# Newmar Corporation Warranty Department

TSB 363

**Subject:** Ground wire sizing for electric leveling jacks.

**Affected Units:** This recall is for specific isolated 2008-2009 All Star ME, 2008-2009 Ventana DP, 2009-2010 Dutch Star DP and 2008 Kountry Star DP.

Figure 2

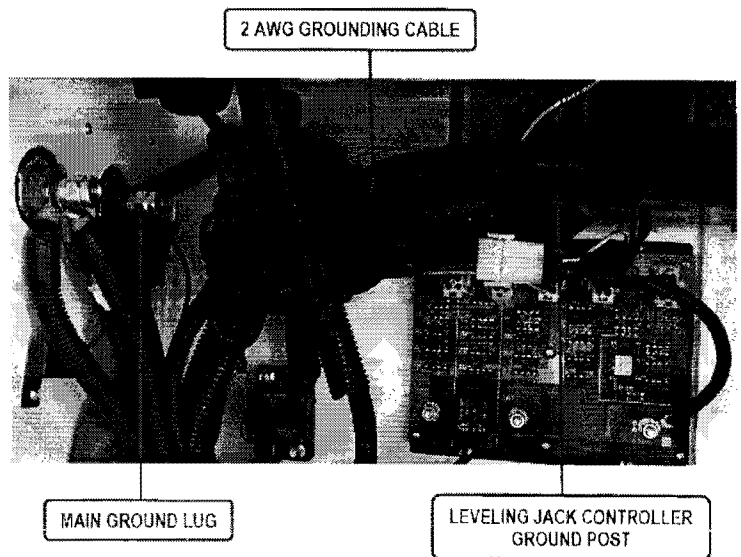
- Measure length of 2 AWG cable required and cut to length. Strip cable ends and crimp ring terminals to cable.
- Attach small ring terminal of 2 AWG grounding cable to the ground post of the leveling jack controller (Figure 2) and large ring terminal to the main ground lug.
- Reset leveling jack controller per instructions in the owner's manual.

*Note 1: The existing 10 AWG ground cable connected to leveling jack controller ground post does not need to be removed.*

*Note 2: Torque conductive nut on the controller ground post to 20 – 20 in/lbs. Torque conductive nut on the main ground lug to 6 – 8 ft/lbs.*
